**SUM-76-10.00**

**MAIN/BROADWAY INTERCHANGE**

**CITY OF AKRON, SUMMIT COUNTY**

TYPICAL SECTION - GARAGE DRIVE

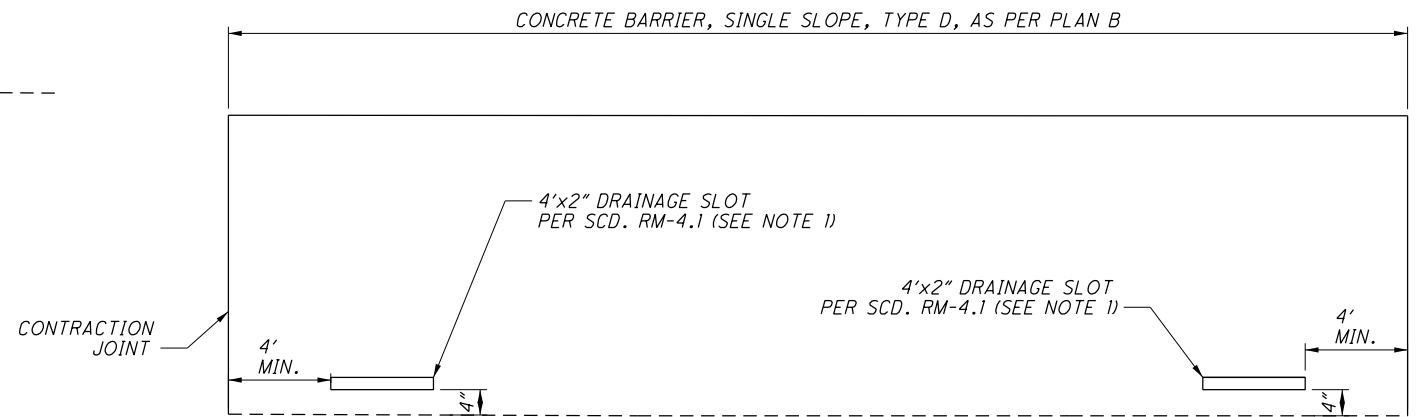
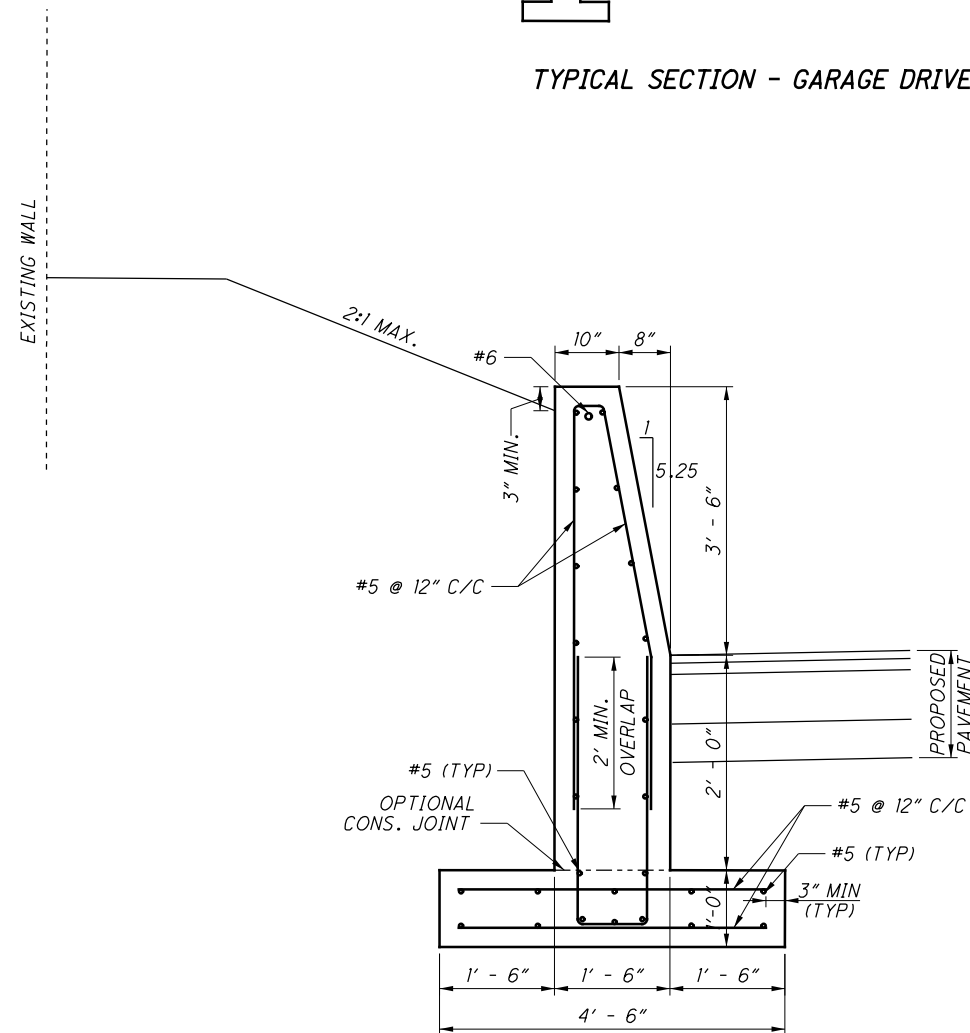
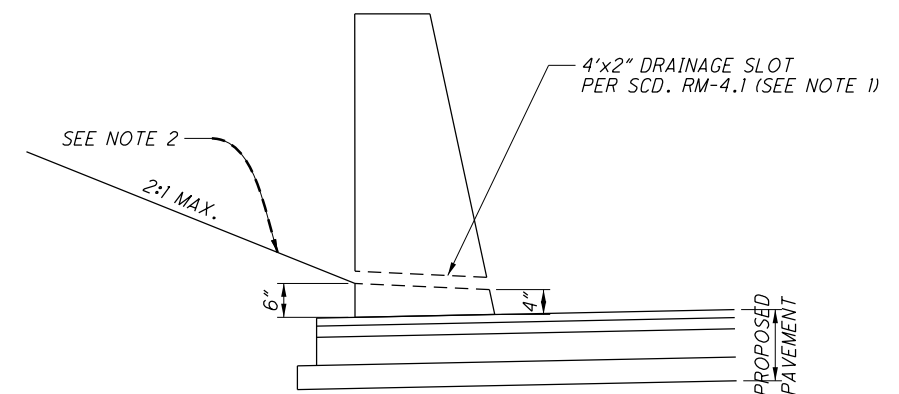
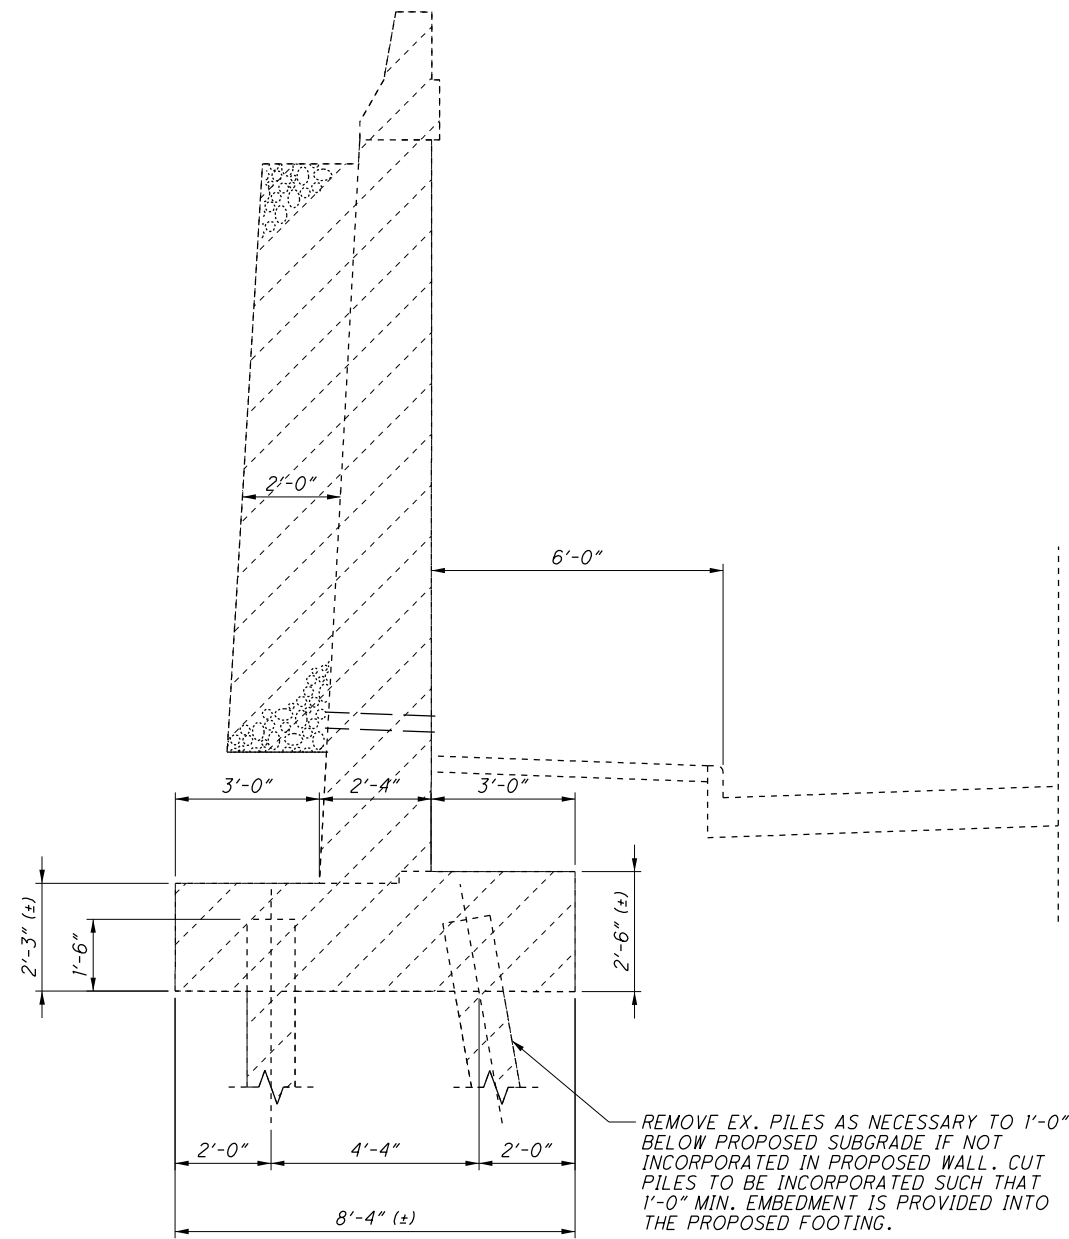
KMK	5/5/16	BARRIER DIMENSION REVISED- APP "A" REVISED
<b>REV. BY</b>	<b>DATE</b>	<b>DESCRIPTION</b>
DATE COMPLETED

- ALL METHODS AND MATERIALS SHALL CONFORM TO ODOT CMS AND SCD UNLESS OTHERWISE NOTED HEREIN.
- ① DRAINAGE SLOTS SHALL BE PROVIDED AT 2 SLOTS PER 20 FEET OF BARRIER AND SHALL BE LOCATED A MINIMUM OF FOUR FEET (4') FROM A CONTRACTION JOINT AND ADJOINING A DRAINAGE INLET OR BARRIER TRANSITION
  - ② THE SLOPES SHALL BE PLACED SUCH THAT THE RUNOFF CAN FLOW UNDER THE CONCRETE BARRIER, TYPE D, AS PER PLAN B ON TO THE MAINLINE SHOULDER THEN INTO THE MAINLINE SHOULDER INLET

THIS MODIFIED BARRIER IS TO BE USED ALONG GARAGE DRIVE.

EXISTING WALL SECTION WITH MODIFIED TYPE D BARRIER

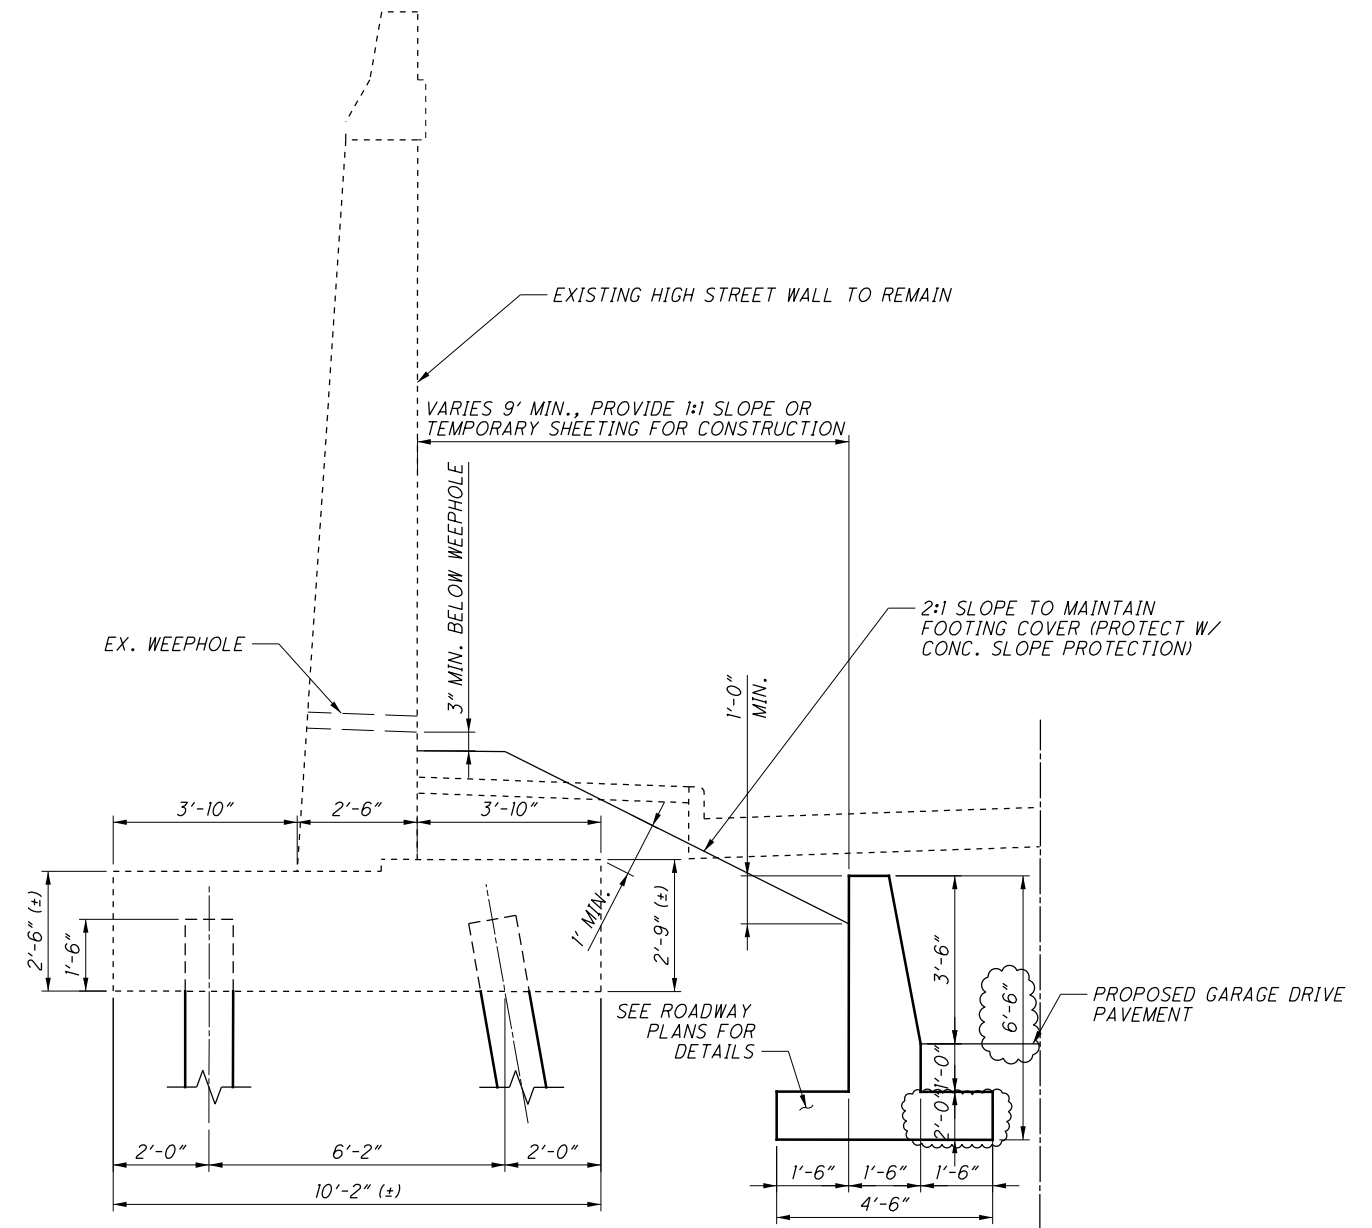
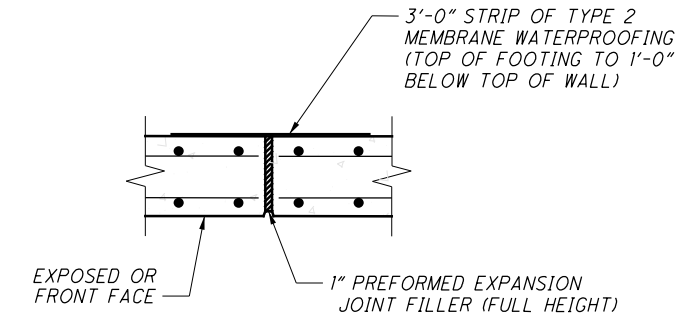
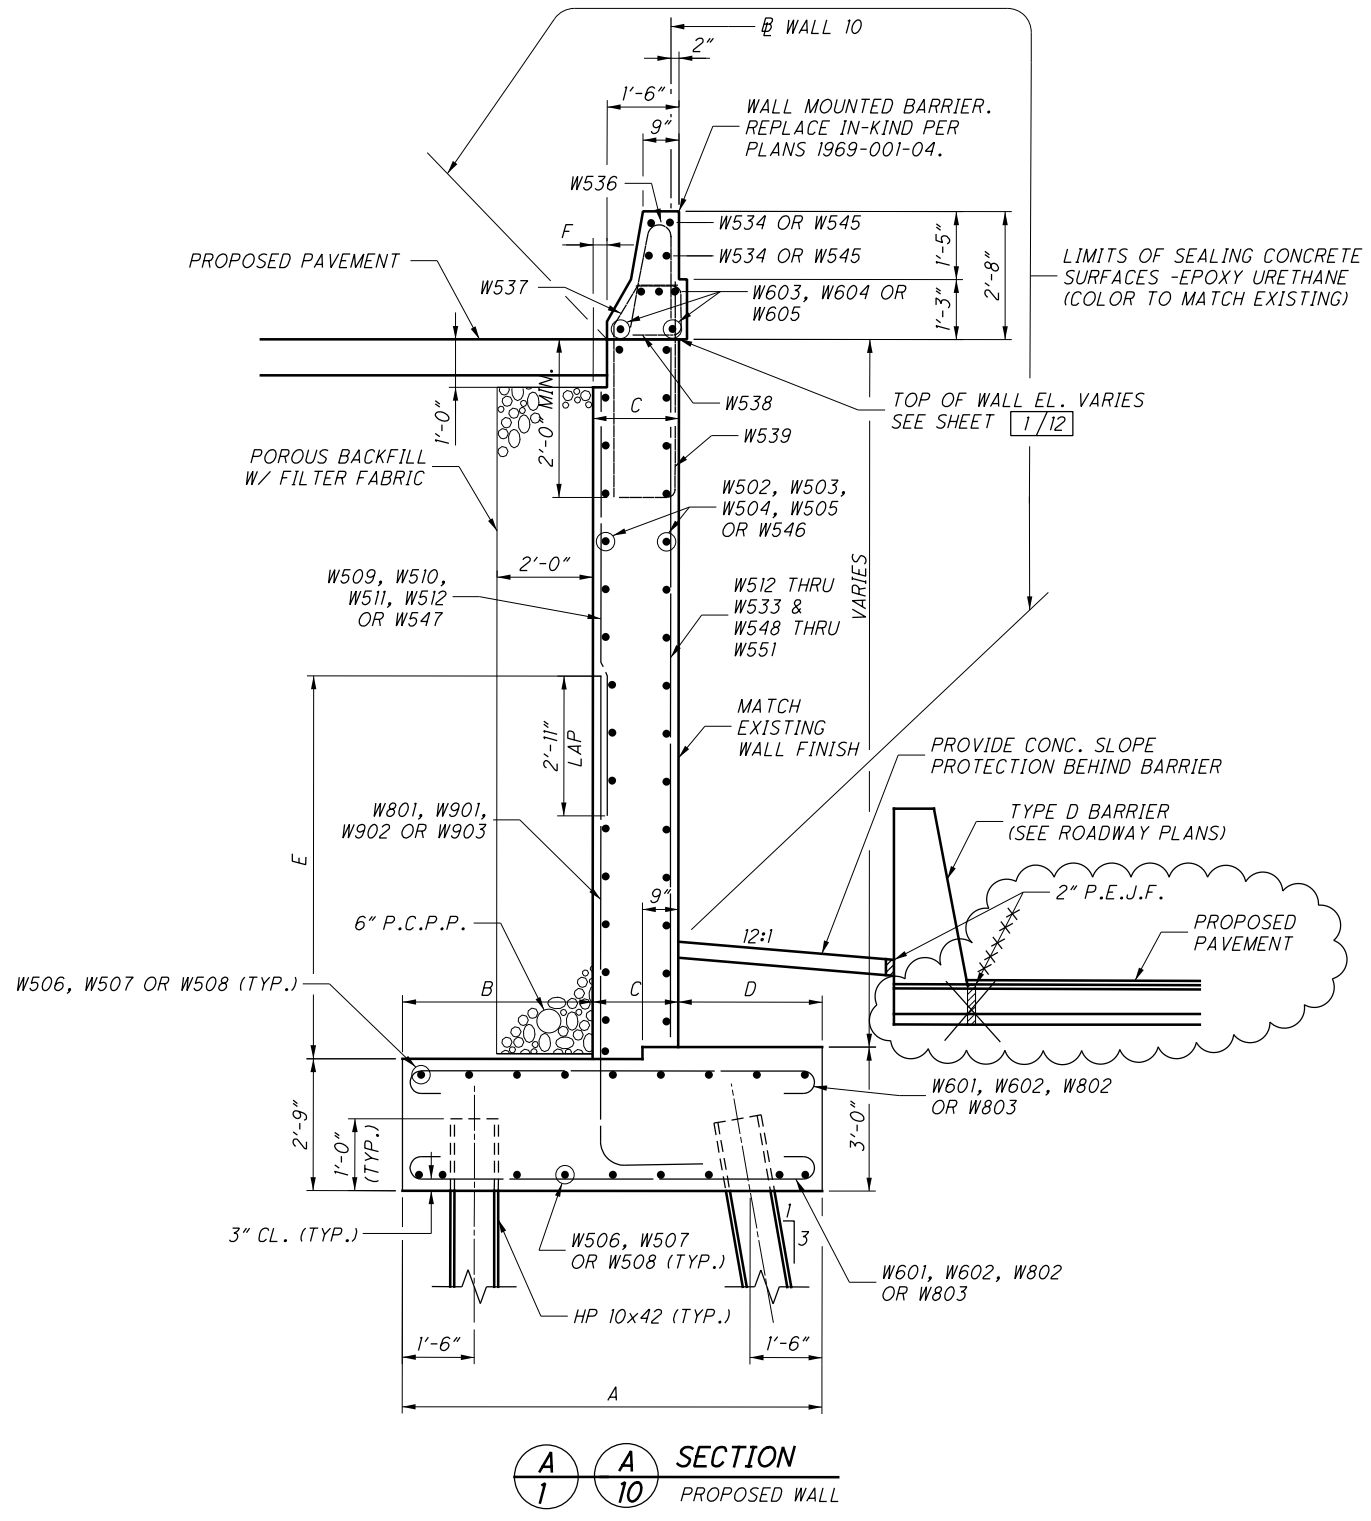
REV. BY	DATE	DESCRIPTION
KMK	5/5/16	BARRIER DIMENSION REVISED

**EXPANSION JOINT DETAIL**

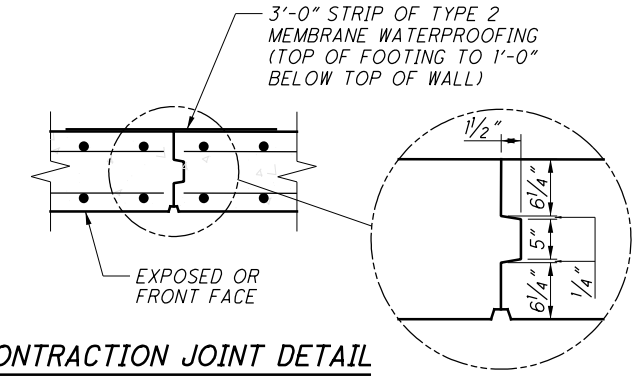
REV. BY	DATE	DESCRIPTION
KMK	5/5/16	PEJF REMOVED - PAVEMENT BUILD-UP REVISED TO MATCH TYPICALS
